### Design Guide for Signs Assessment

**Date:** 27/06/2022  
**Comments to:** Elliott Thornton, Consultant Planner  
**Comments from:** Sarah Duffell, Senior Urban Designer RMA  
**Plans/drawing set:** Appendix 3: Signage and Appendix 4: Photomontages supplied with application

This proposal is to erect a digital billboard sign on top of the Huddart Parker building, which is a listed heritage building in the District Plan and located within the Post Office Square Heritage Area.

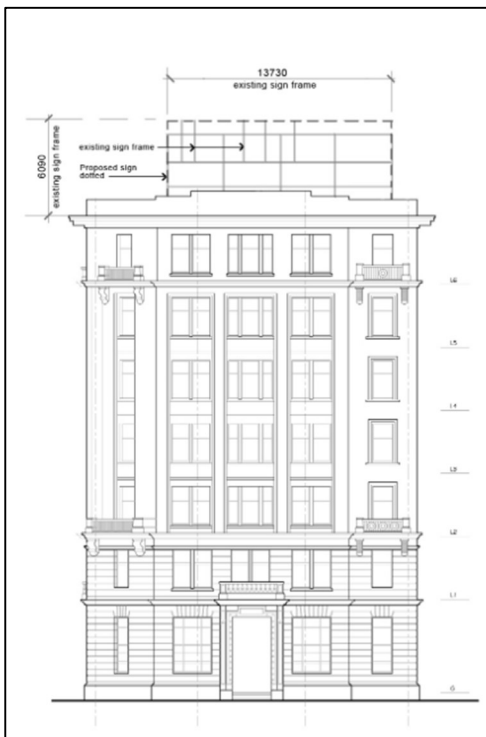
- Notwithstanding that the sign would be outside the margins of the catchment identified in Viewpoint 9 of the District Plan, it is considered that the sign would be visually obtrusive in the elevated view from The Terrace along Grey Street to the waterfront. (See image to the right, from District Plan.)

View from Grey Street

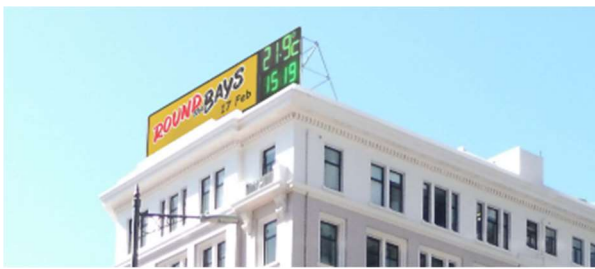
- The application commits to a high standard of design.
- It does not appear that the rear of the sign would be readily visible from any nearby or significant public viewpoint.
- The support structure is existing, and would not be readily visible once the sign is installed except in side views – see pictures below (from application). It is relatively lightweight in appearance.

- The support structure is in existence now but it doesn’t logically follow that it should be used just because it’s there. It appears as a scaffold on the top of the building, and although the applicant argues that this sign and its structure have sentimental value to Wellingtonians, given the ten-year lapse in a sign in this location many would not even know or remember what was there now that it’s gone. The visual quality of the top of the building – a listed heritage structure - would also be improved if the frame was removed rather than re-used.
